**PURPOSE STATEMENT**  
FOR REVISION #5  
THE PURPOSE OF THIS REDLINE IS TO ADD 13,29'x40' BATHROOM EXPANSION TO THE EX. COMMUNITY BUILDING, HANDICAP SPACE, CONCRETE STOOP AND REVISE THE STORMWATER MANAGEMENT FACILITY.

**PURPOSE STATEMENT**  
FOR REVISION #6  
THE PURPOSE OF THIS REDLINE IS TO REPLACE THE EXISTING POOL DECK (TRAINING POOL, ADD STORMWATER FACILITIES & DETAILS.

**PROJECT TITLE:** LOUGHELOW NEIGHBORHOOD CENTER 5TH ELECTION DISTRICT, HOWARD COUNTY  
SUBJECT: M 29 2731, LOT 1, 2, 3

**AS-BUILT SITE PLAN**

**MICRO-BIO-RETENTION FACILITY #1  
ENLARGED VIEW OF FILTER BED AREA  
MICRO-BIO-RETENTION PLAN (M-6)**  
SCALE: 1"=5'

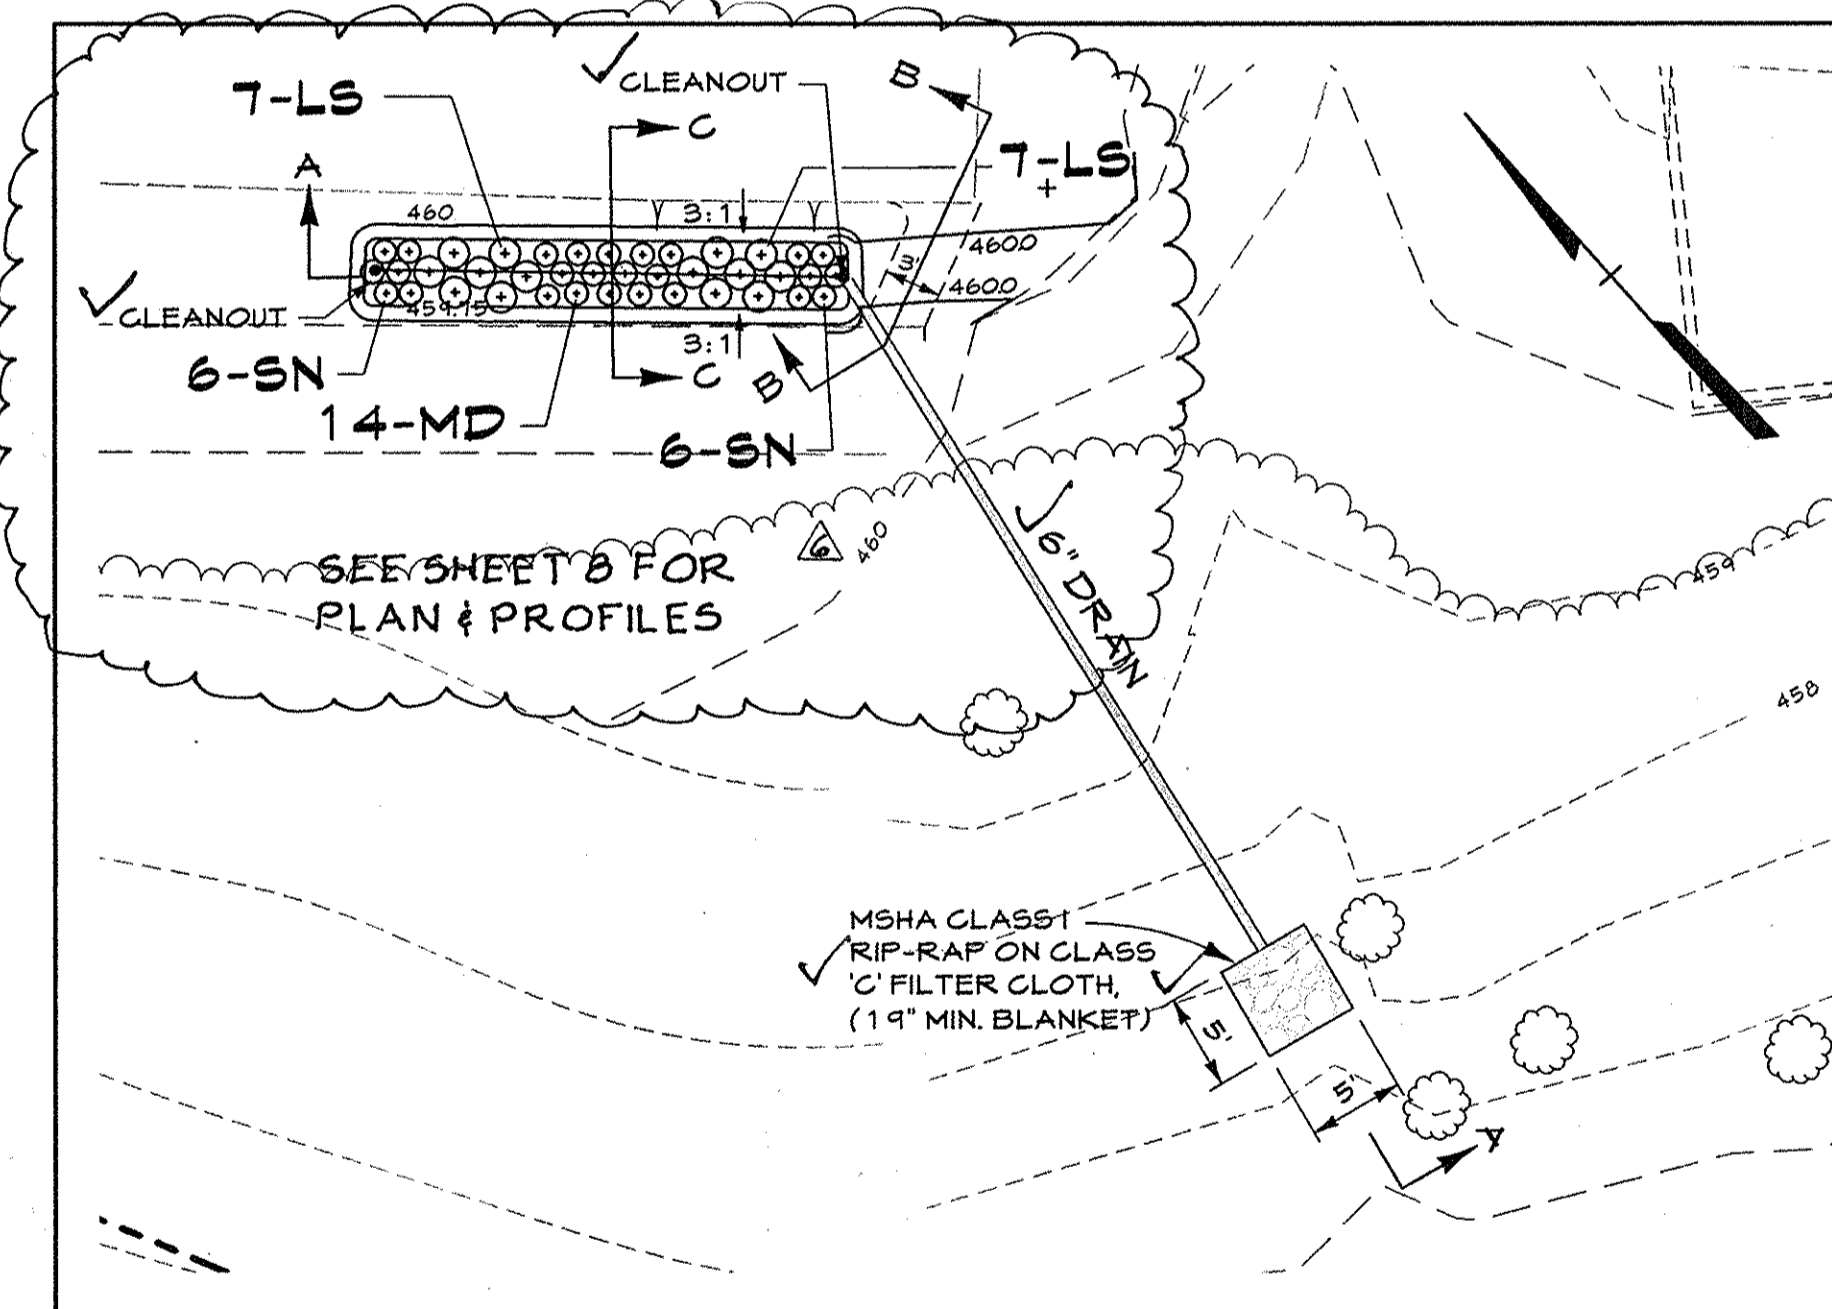
**PURPOSE STATEMENT FOR REVISION #6**  
THE PURPOSE OF THIS REDLINE IS TO REPLACE THE EXISTING POOL DECK & TRAINING POOL. ADD STORMWATER FACILITIES & DETAILS

THE PURPOSE OF THIS REDLINE IS TO ADD 13.29' x 40' BATHROOM EXPANSION TO THE COMMUNITY BUILDING, CONCRETE STOOP, STORMWATER MANAGEMENT FACILITY, AND REVISE THE EXISTING HANDICAP PARKING SPACE.
